OIL - ENGINE - REPLACE MAIN OIL SCAVENGE PUMP MOUNTING FLANGE PACKINGS - CATEGORY CODE
6 - MOD.ENG-79-0049

Main Oil Scavenge Pump Packings
Fig.1

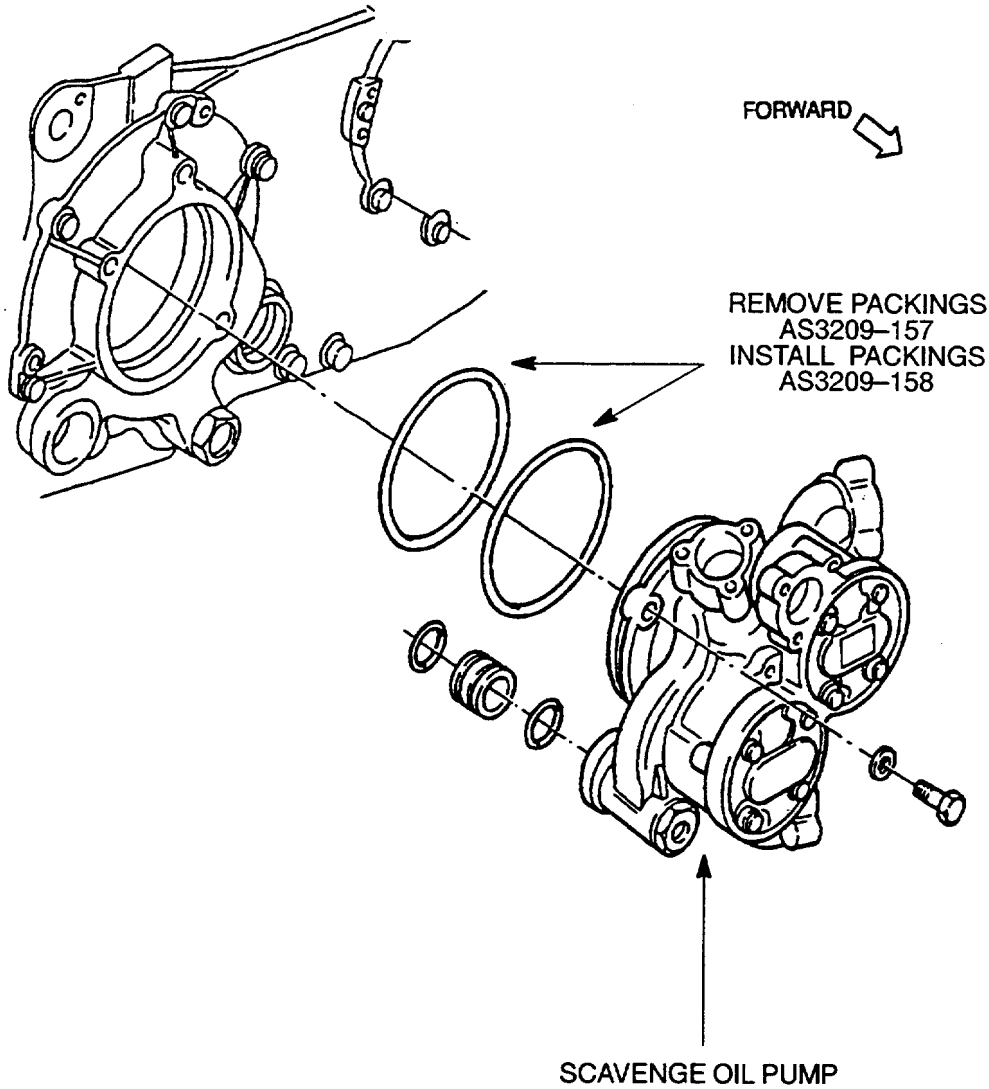
- (1) Condition
Smoke has been observed in the tailpipe at engine shutdown.
- (2) Background
Inadequate scavenging of No.5 bearing compartment oil.
- (3) Objective
To improve scavenging of the No.5 bearing compartment.
- (4) Substantiation
Positive results observed during engine test
- (5) Effects of Bulletin on Workshop Procedures:

(a) The larger packings on the oil scavenge pump installation mounting flange.

(1) Install the new packings AS3209-158. See Figure 1. Use the procedure given in Reference (1) or (2), Chapter/Section 72-60-00, Assembly, TASK 72-60-00-432-001.

New Part No< (ATA No.)	Qty	Est'd Unit Price (\$)	Keyword	Old Part No. (IPC No.)	Instruction Disposition
AS3209-158 (79-22-41)	2	9.28	.Packing	AS3209-157 (01-034)	(A) (B) (S1)
